Planning application 2023/5480/P (the "Application") registered on the Camden Planning website on 02-02-24 by BreeLayne Carter (the "Applicant")

Comments from Alexander Ryazantsev and Mary Ryazantsev of 131 Haverstock Hill

We refer to the Planning Application 2023/5480/P and Listed Buildings Consent application 2024/0055/L for works at 133 Haverstock Hill NW3 4RU, which is a property that is part of the same terrace as ours.

Plan from Arboricultural survey for 133 dated Dec-23

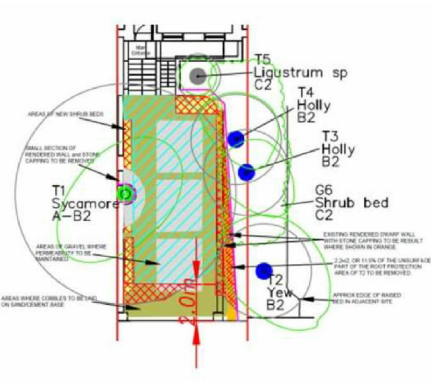
- There is a discrepancy between the arboricultural survey commissioned for the Application (the "133HH Survey") with the one performed in relation to an earlier application 2021/2621/P for 131HH (the "131HH Report"). The 133HH report shows that both hollies ("T5" and "T6" in the 133HH Survey and "T3" and "T4" respectively in the 131HH Report) are positioned on the land belonging to 133HH, while the 131HH Report suggests that the T5/T3 sits on the actual boundary, while T6/T4 is on the land that belongs to 131HH.

- We fully appreciate these surveys may well be not precise enough to have a clear answer as to which land exactly these hollies are on, however, it's fair to suggest that some of these trees are likely to be fully or partially on or very close to the boundary.
- For the record, we oppose the felling of these and other trees in the front garden. Felling of these trees would have a significant impact on the natural habitat as well as on the privacy [REDACTED]. In addition to privacy, trees offer sound dampening from the main road. These trees are 30 feet tall with mature stature. See image attached below.
